> Customer Product Information (CPI)

Product group: SEMIX	Rev.: 0
No.: PN20-063 Modification of ESD tray	20 Jun 2020

Subject of change: Optimisation for SEMiX 3s printed with Phase-Change-Material

Detailed view

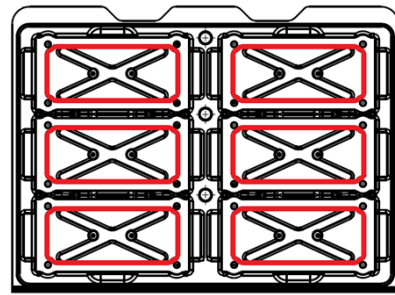
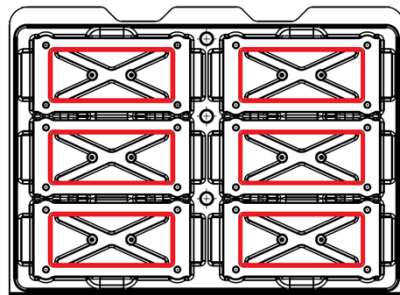
Description of change: Extension of deepened area in bottom part of ESD tray

Reason for change: Avoid collision of printed Phase-Change-Material with ESD tray in peripheral areas
